IEEE P802.11

Wireless Access Method and Physical Layer Specification

Exorcising the Ghosts of Connections (and RT Encryption)

Summary

Figure 5-4: Construction of expanded WEP MSDU

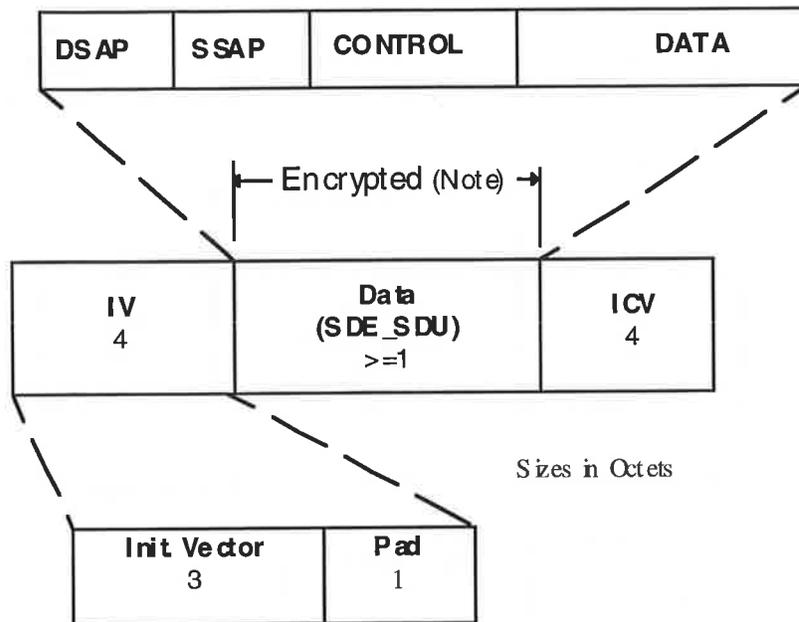
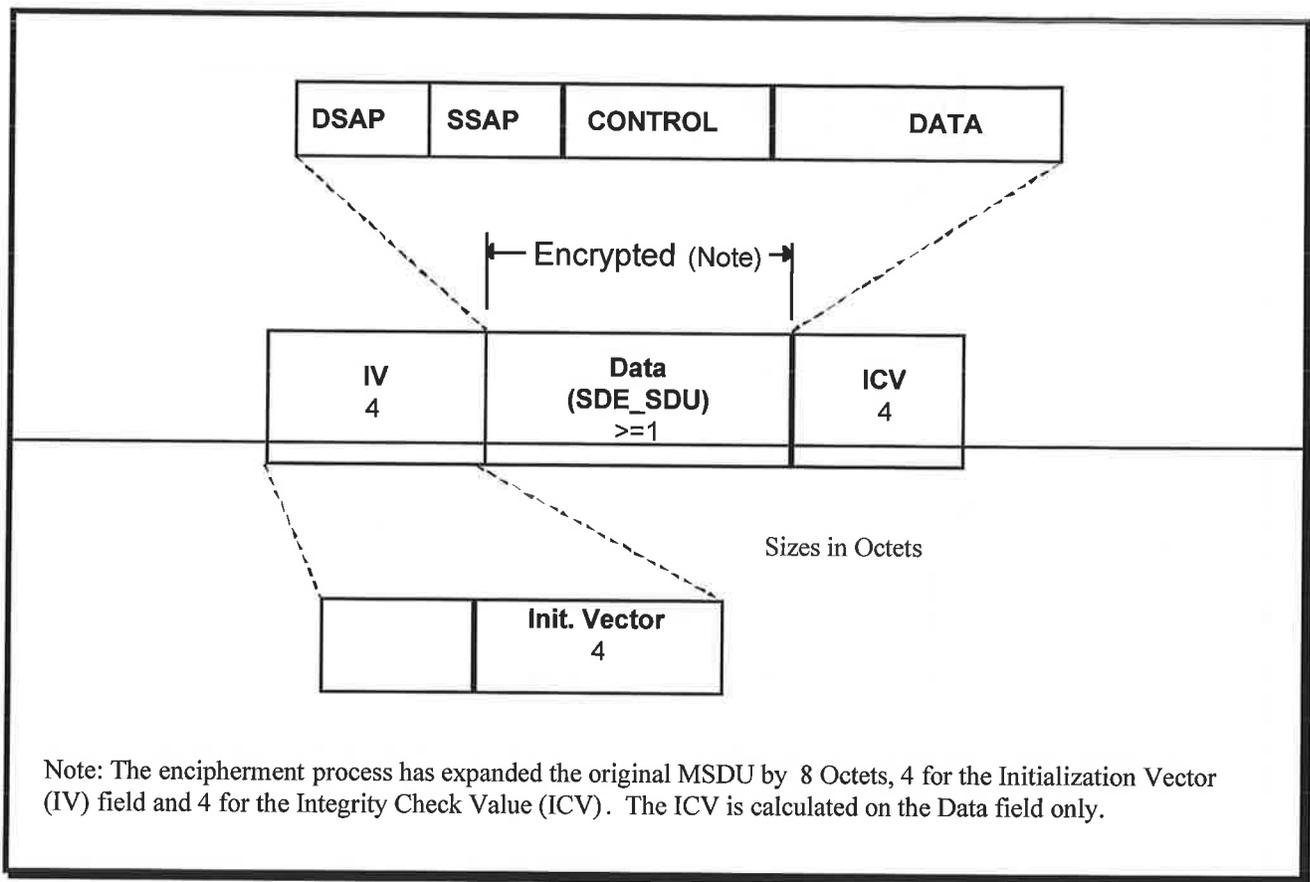
Figure 5-4 shows the encrypted MSDU as constructed by the WEP.

The WEP ICV = 32 bits. The expanded MSDU shall include a 32 bit IV field immediately preceding the MSDU. This field shall contain ~~two~~ one sub-fields: A 34-octet field that contains the initialization vector and a 1-octet pad field to maintain even-octet alignment of the encrypted payload.

Note: The encipherment process has expanded the original MSDU by 8 Octets, 4 for the Initialization Vector (IV) field and 4 for the Integrity Check Value (ICV). The ICV is calculated on the Data field only.
